TECHNICAL BULLETIN INDEX
Sorted by Bulletin Number
04/03/86

BULLETIN NO: II:1

PRODUCT: 26-4001/2 Model II

Figure 1

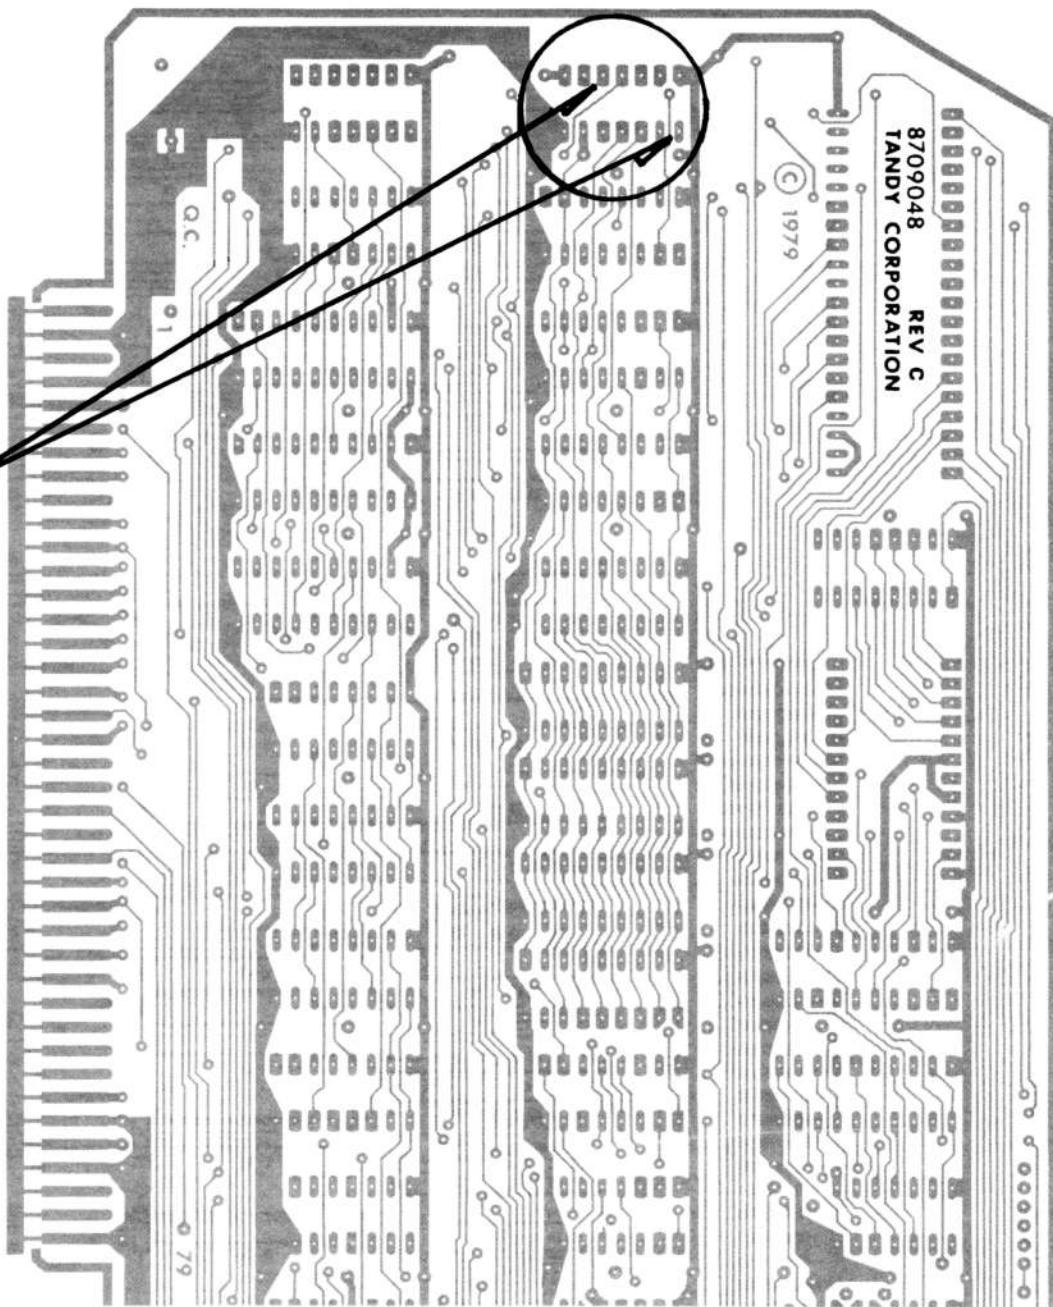
PURPOSE: To correct dual addressing on Video/Keyboard Interface boards (Rev A/B).

PROCEDURE: Whenever a Rev C VDG board is replaced with a Rev A or B VDG board jumper pin 1 to pin 10 of U27 on the Rev A or B board to insure no addressing conflict of the VDG board (Refer to Figure 1).

FIG 2

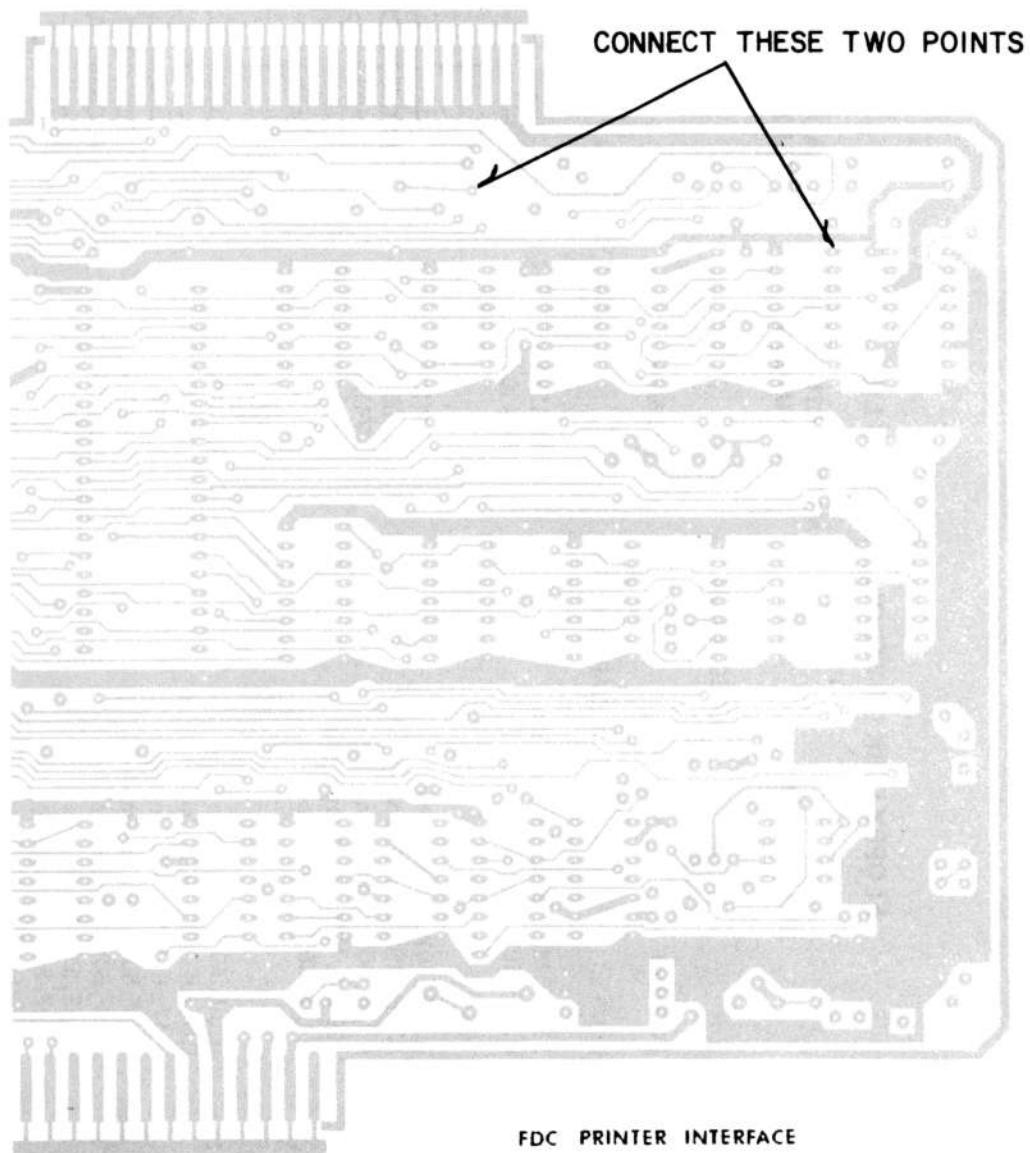
PROCEDURE: On unmarked, Rev A, or Rev B boards make sure the "one shot" modification has been installed (Refer to Technical Bulletin II:9), or that long jumpers are installed on the back of the board running to U37. Disregard this step on Rev C and D boards as they have this modification incorporated into their circuitry. On ALL revisions of the current board with a SY1791-02 FDC chip installed, add a jumper wire on the back side of the board from U1 pin 1 to the trace connected to TP10 (Refer to Figure 2).

Figure 1

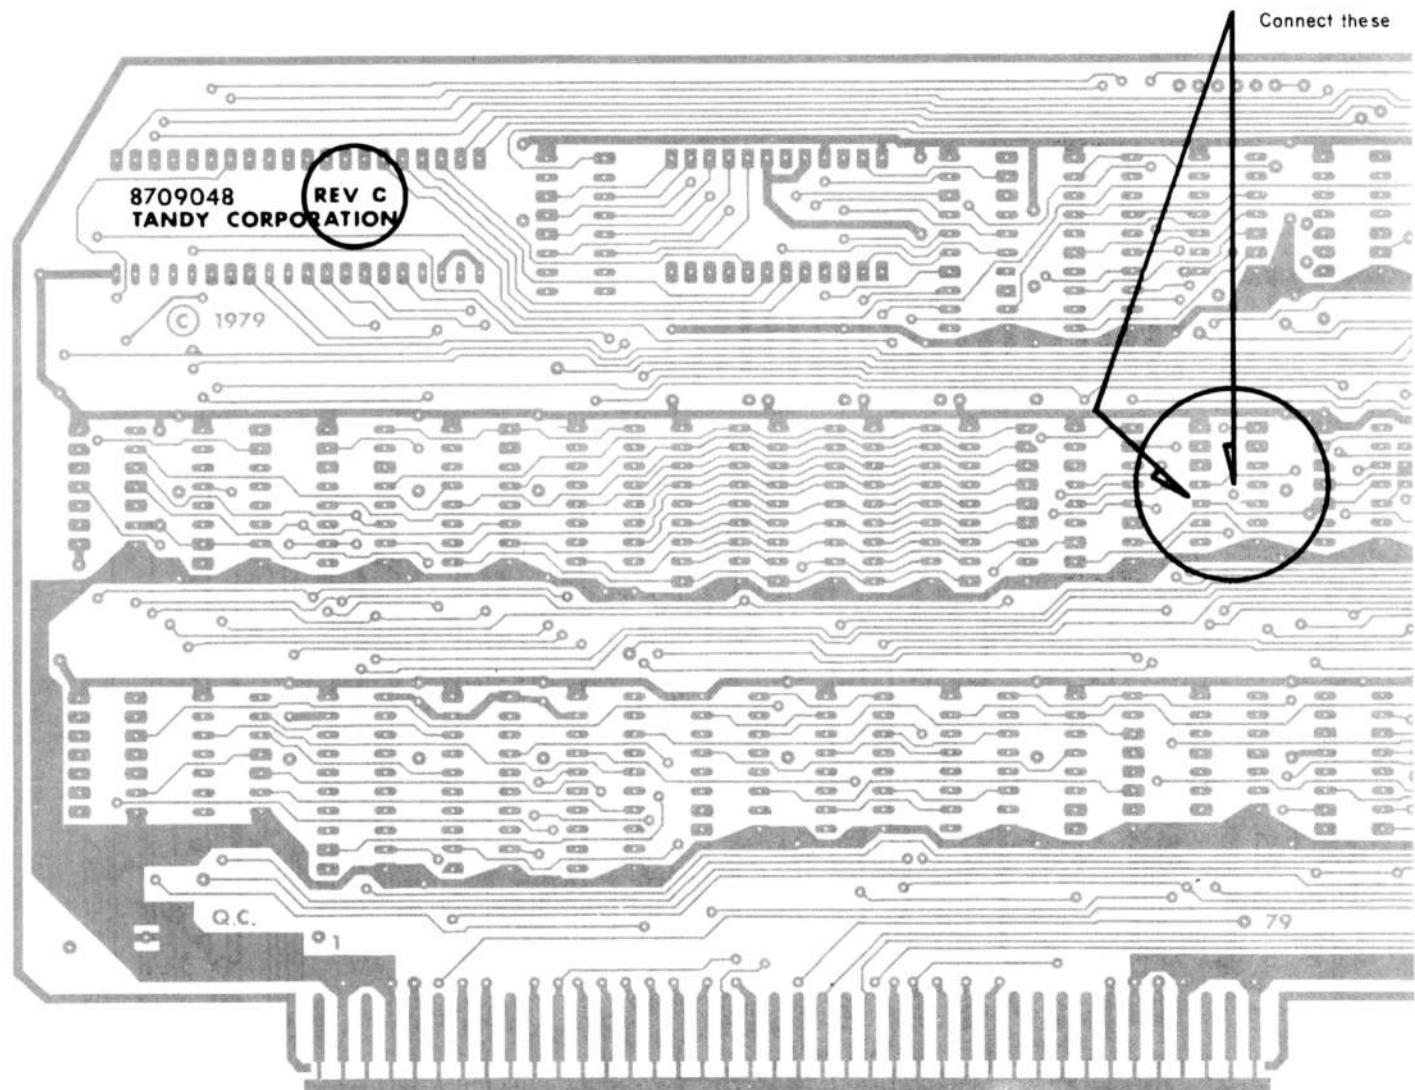
DISCUSSION: On Rev C VDG boards made by Lika there is a trace missing to the clear line on the latch (U17) that generates KBIRQ*. This can generate random interrupts that may or may not be fatal. To correct this problem a jumper is added to correct the missing trace which is a pullup to the clear line of U17. To identify the board as being manufactured by Lika, look for the Rev C marking on the solder side of the board under the 6845 chip and by LEI etched also on the solder side the crystal. This is the ONLY board to which this fix applies.

PROCEDURE: On the solder side of the board there is a feedthru located beneath the middle of U17 that is not connected to anything. Run a short piece of wire from that feedthru to U17 Pin 10 (Refer to Figure 1).

Figure 1

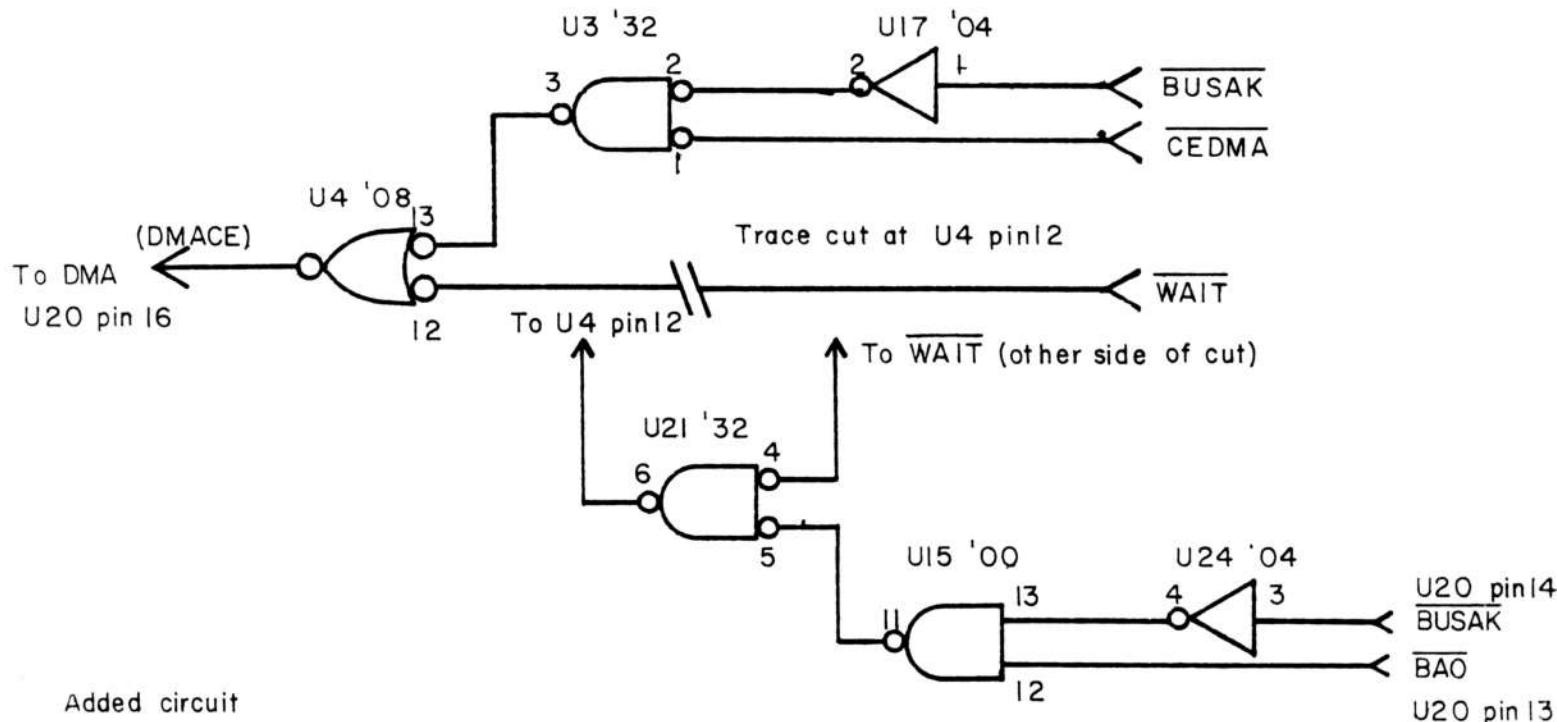
DISCUSSION: This modification is the same as the Hard Disk modification except it does not include anything unique to the Hard Disk such as the Boot ROM. Rev A, B, and C boards are the ONLY CPU boards to which this modification applies. DO NOT perform this modification on Rev D and later boards as they have this modification incorporated into their design. Refer to Figures 1 and 2 for schematic changes affected by this modification.

Figure 2

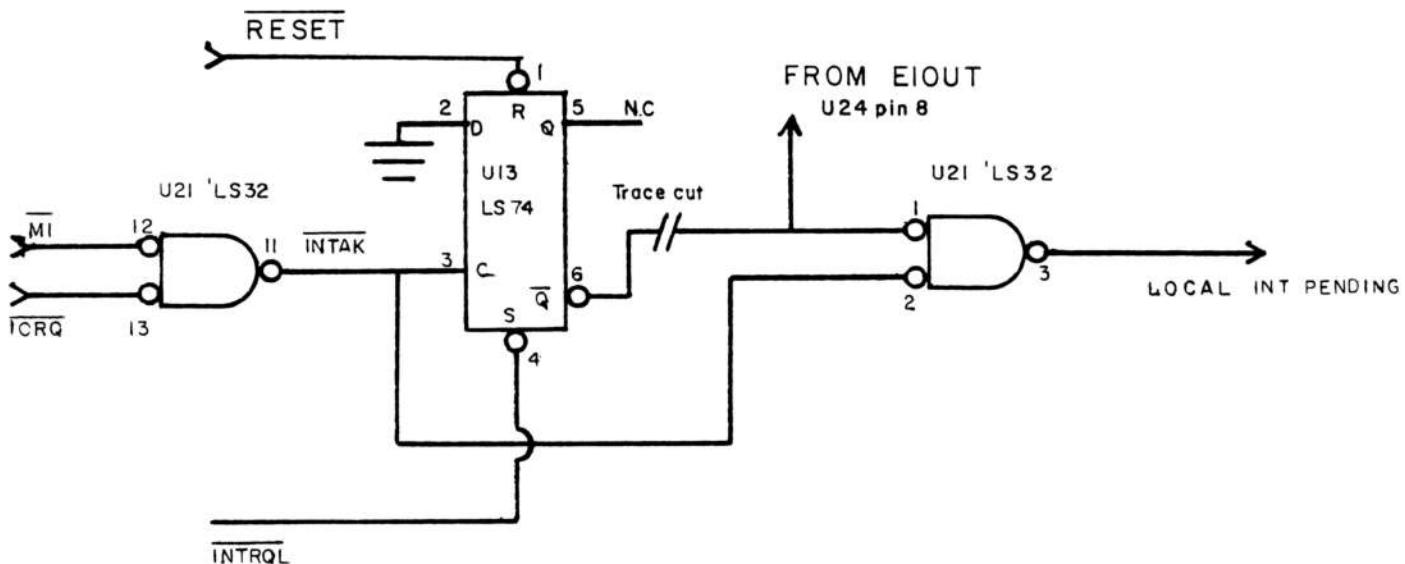
U21 pin 1 to U24 pin 8
U4 pin 12 to U21 pin 6
U21 pin 4 to WAIT* (the first feedthru after the cut at U4 pin 12)
U21 pin 5 to U15 pin 11
U15 pin 12 to U20 pin 13
U15 pin 13 to U24 pin 4
U24 pin 3 to U20 pin 14

Figure 1

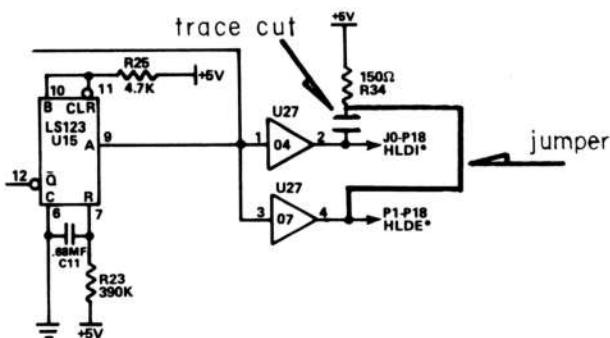
DISCUSSION: On the redesigned FDC board (Rev Blank) there is a pullup resistor on the Head Load signal for internal drives, but there is none for external drives. With the Model II the internal drive has Head Load termination on the board but the bay does not. With the FDC board (Redesign) this means that the internal drive has double Head Load termination while the external Head Load signal has no pullup. To correct this problem we eliminate the internal Head Load signal on the FDC board and use its pullup for the external Head Load signal (Refer to Figure 1).

Figure 3

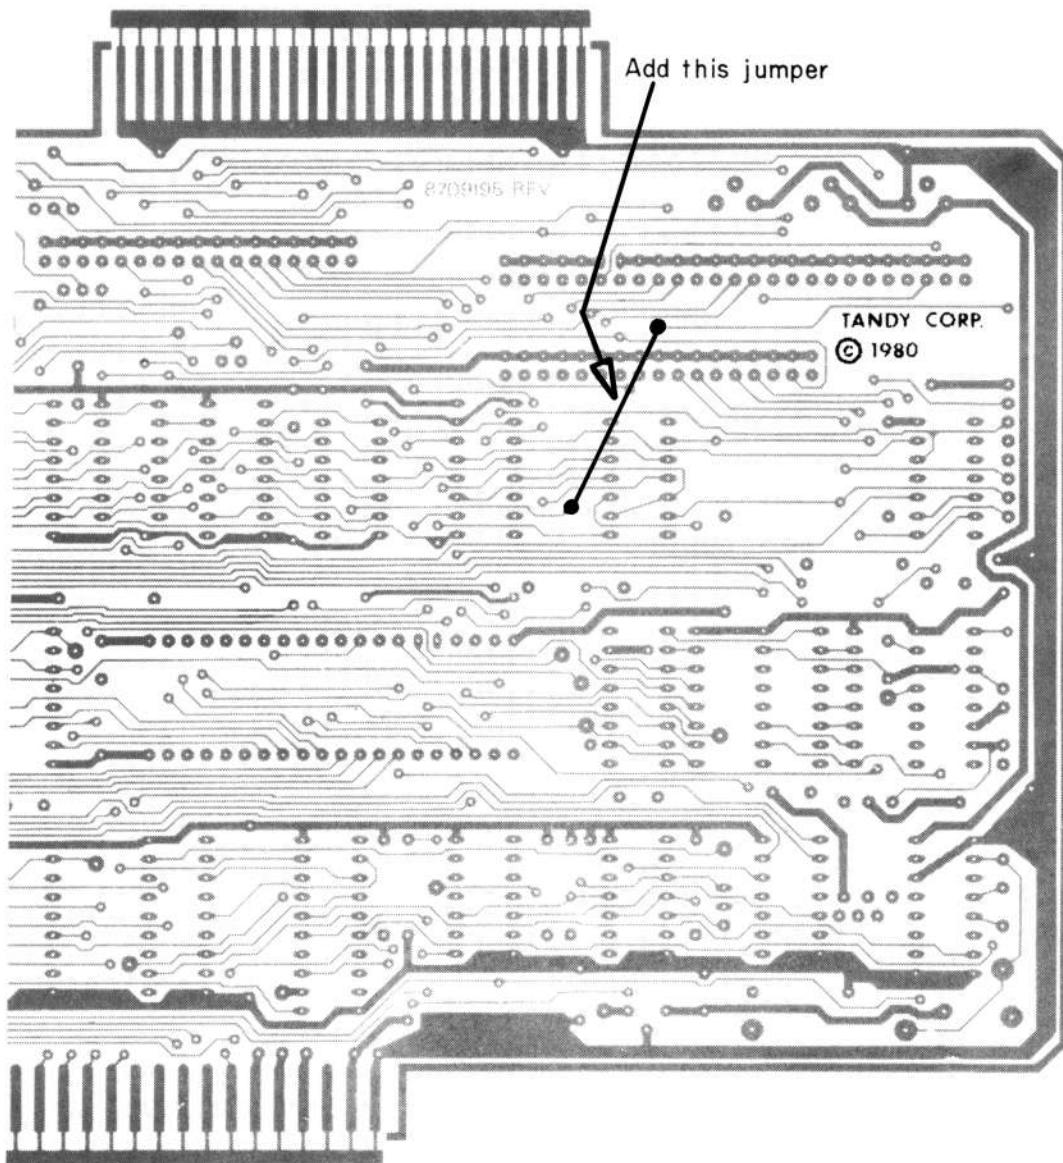
1. On the component side, cut the trace that goes to pin 18 of J0 (the 50 position pin header connector) RIGHT AT the connector so that the feedthru can still be used on the reverse side to go to the external head load signal (Refer to Figure 2).
2. Turn the board over to the solder side and solder a jumper from the feedthru referenced in step 1 (this is the pullup resistor line) to the feedthru between U8 and U9 that is closest to pin 8 and 9 of U8. This feedthru is the Head Load external signal external signal and goes over to U10 on the solder side of the board (Refer to Figure 3).

Figure 1

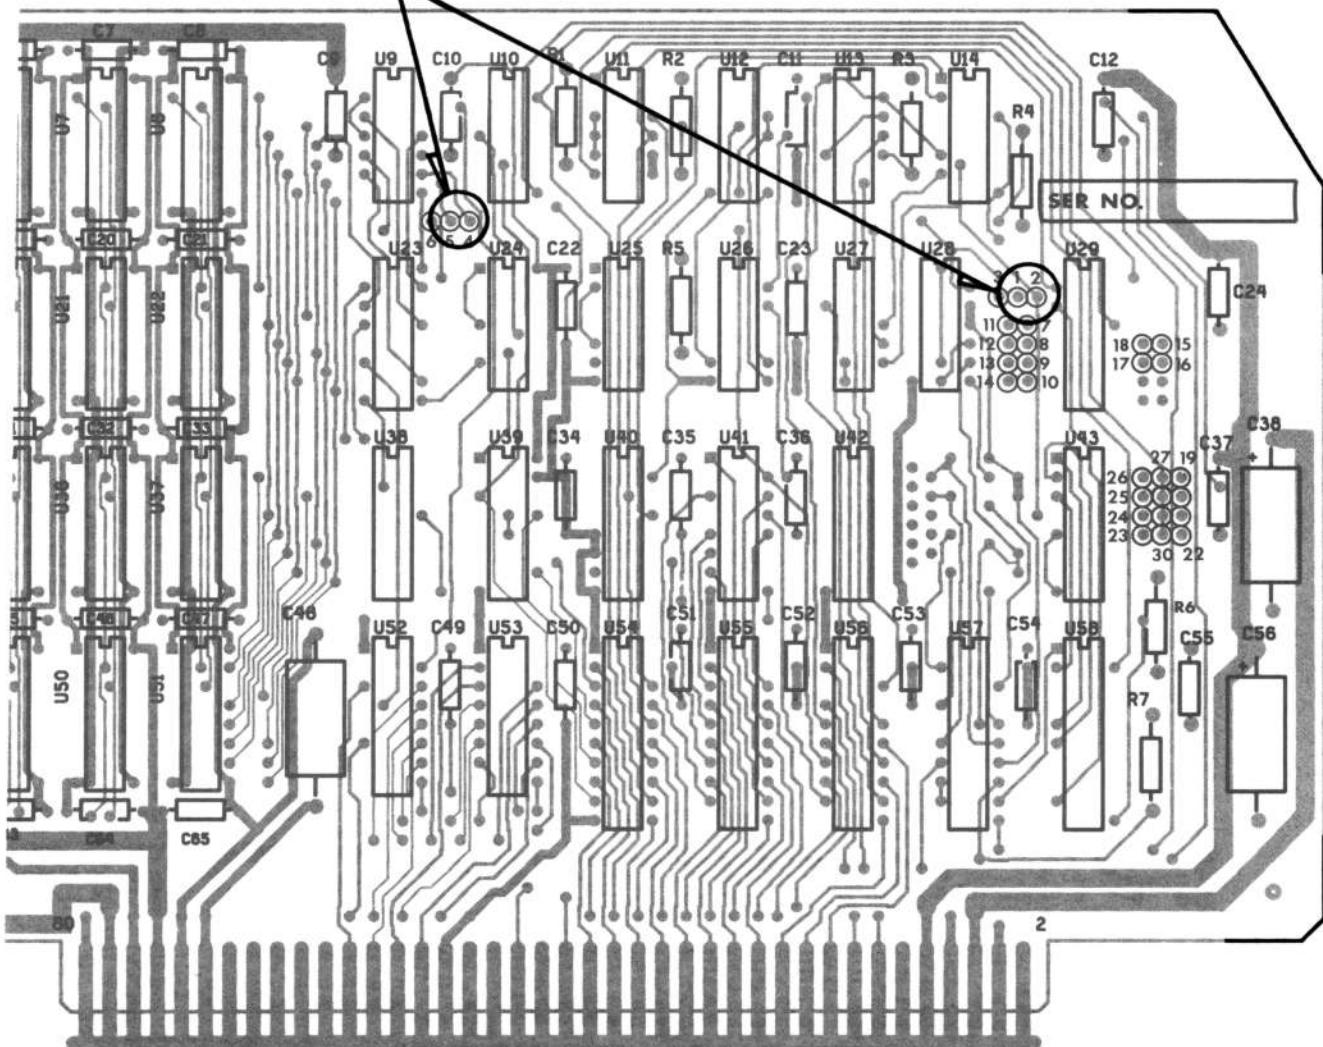
DISCUSSION: Pullups are needed on memory boards for inputs to gates. Intermittent problems can occur without these pullups installed. Some of the Model II memory boards may be missing staking pins for push on connectors and appropriate markings. In this case, use wirewrap to jumper the pads and refer to Figure 1 for pad locations.

PROCEDURE: Check boards for proper jumpering and install jumpers if they are missing. For physical locations of jumpering positions refer to Figure 1 for the memory board and Figure 2 for the Interface board.

Model II Memory boards:
Jumper 1-2 and 5-6
